SERVICE BULLETIN

Bulletin No. SB 35/36-30-10

Date: June 28, 1998
 Revision 1 February 12, 1999

ICE AND RAIN PROTECTION - Replacement of Wing Anti-Ice Transverse Duct

Detail B

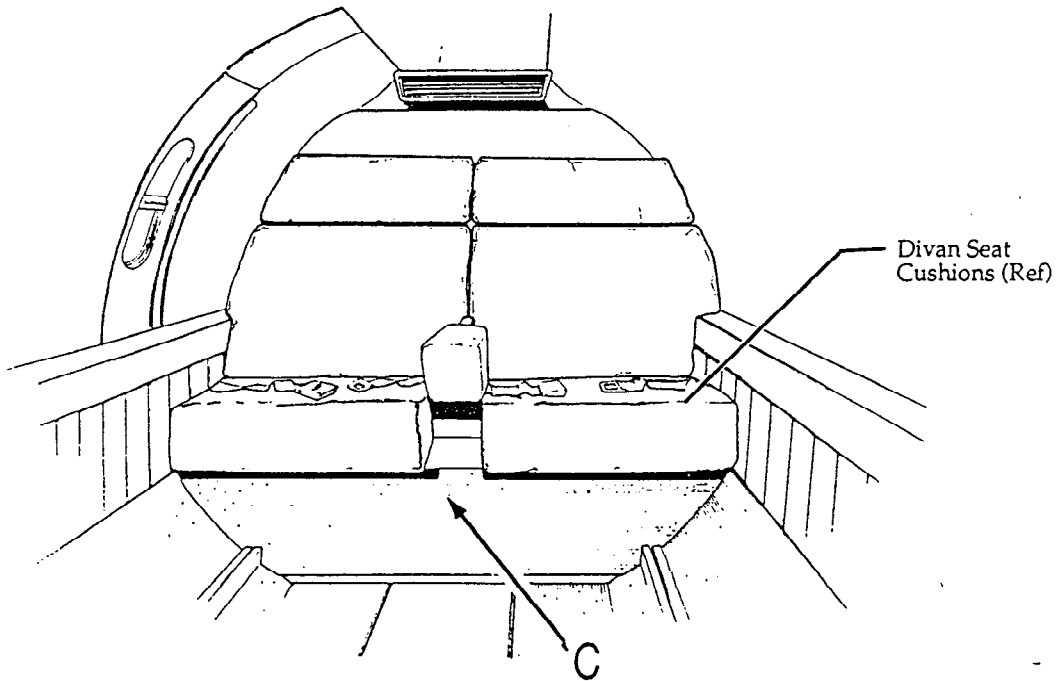
- (1) Disconnect aircraft batteries.
- (2) Remove aft divan seat cushions. (See Detail B.)
- (3) Remove upholstery as necessary to access diffuser assembly (8). (See Detail C.)

Detail C

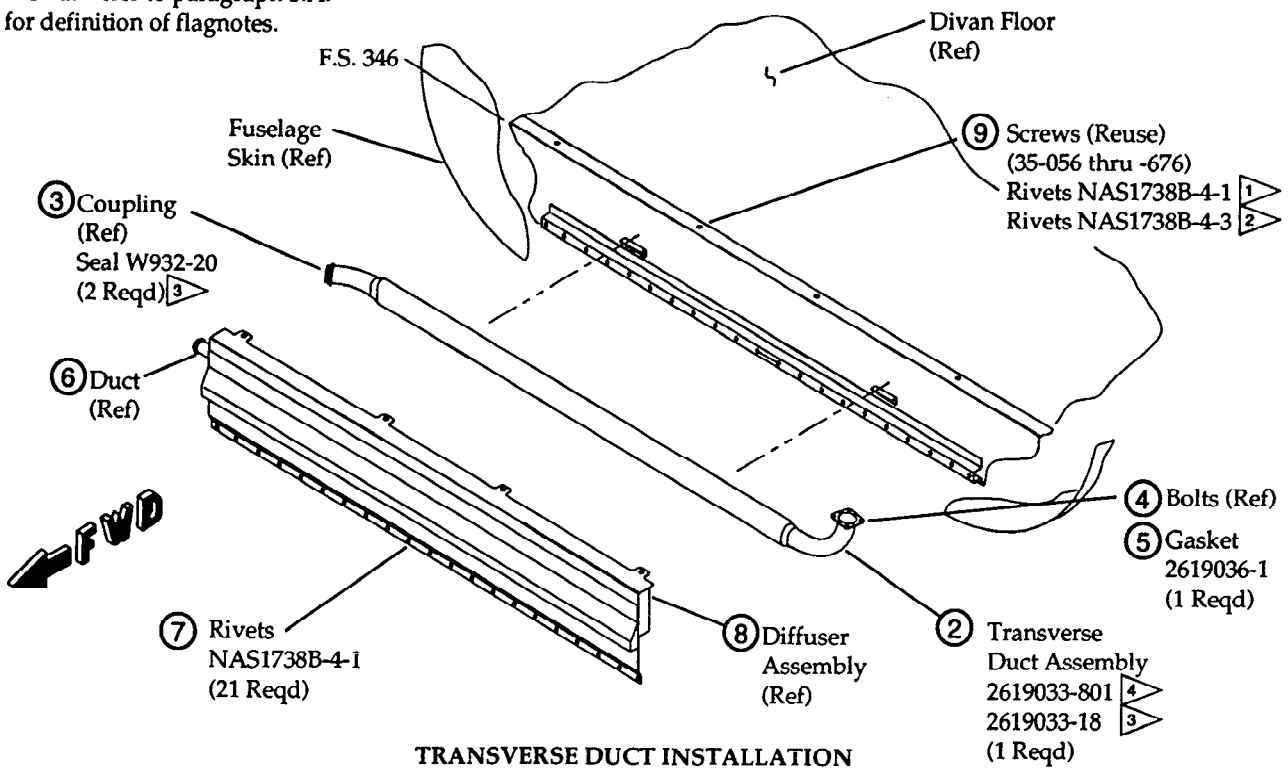
- (4) Disconnect duct (6). (See Detail C.)
- (5) Remove screws or rivets (9) and rivets (7) from diffuser assembly (8). Remove diffuser assembly from aircraft. (See Detail C.)

- (6) Disconnect coupling (3) and remove bolts (4) from transverse duct assembly (2). Discard transverse duct (2), seals (3) and gasket (5). (See Detail C.)

- (17) Install insulator (19) on exit duct assembly (14).
- (18) Position transverse duct (2) and left fuselage exit duct assembly (16) in aircraft.
- (19) Install coupling and seals (3). (See Detail C.) Do not tighten.

- (22) Sequentially tighten coupling (10), coupling (3), and screws (15). If necessary, loosen bolts (4) slightly to achieve proper alignment. (See Detail C and Detail D.)

Detail D

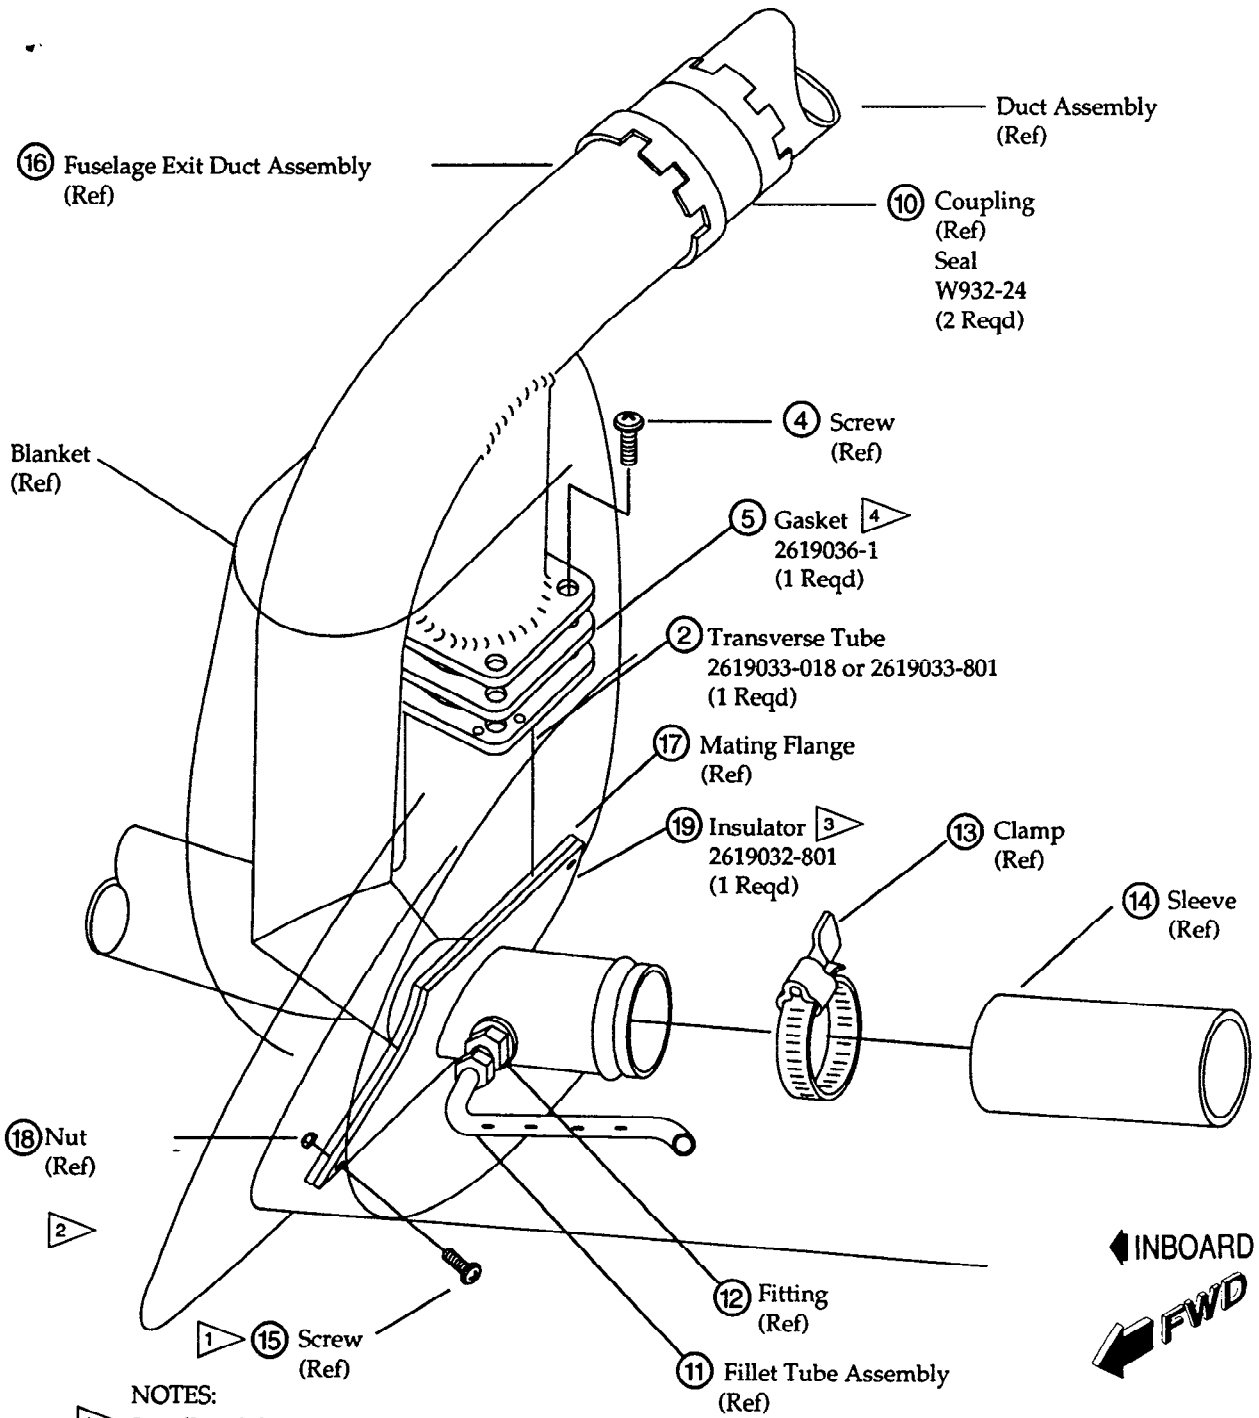
- (7) Remove coupling (10) from left wing exit duct. (See Detail D.)
- (8) Gain external access under cuff fairing area to left fuselage exit duct. (See Detail D.)

- (9) Remove fillet tube assembly (11) and fitting (12) from left fuselage exit duct. (See Detail D.)
- (10) Loosen clamp (13) and remove. Loosen sleeve (14) from left fuselage exit duct assembly (16). (See Detail D.)

- (11) Remove screws (15) and nuts (18) from left fuselage exit duct assembly. (See Detail D.)
- (12) Remove left fuselage exit duct assembly from aircraft. (See Detail D.)

- (16) Apply sealant to left fuselage exit duct assembly mating flange (17) and to mating surface of fuselage. (See Detail D.) (Refer to Learjet Maintenance Manual, Chapter 20, Sealants, Description and Operation.)

- (20) Install coupling and seals (10). (See Detail D.) Do not tighten.
- (21) Install screws (15) through left fuselage exit duct assembly mating flange (17) and fuselage skin. Install nuts (18). Do not final torque. (See Detail D.)

- (23) Install fillet tube assembly (11), fitting (12) and sleeve (14) on left fuselage exit duct assembly (16). Tighten clamp (13). (See Detail D.)
- (24) Perform Cabin Leakage Check. (Refer to Learjet Maintenance Manual, Chapter 21, AIR CONDITIONING, Pressurization Control, Maintenance Practices.) Check for external leaks between left fuselage exit duct assembly (16) and fuselage skin.
- (25) Perform Functional Test of Wing Temperature Sensing and Indicating System and leak check transverse duct (2) and coupling (10). (Refer to Learjet Maintenance Manual, Chapter 30, ICE AND RAIN PROTECTION.)
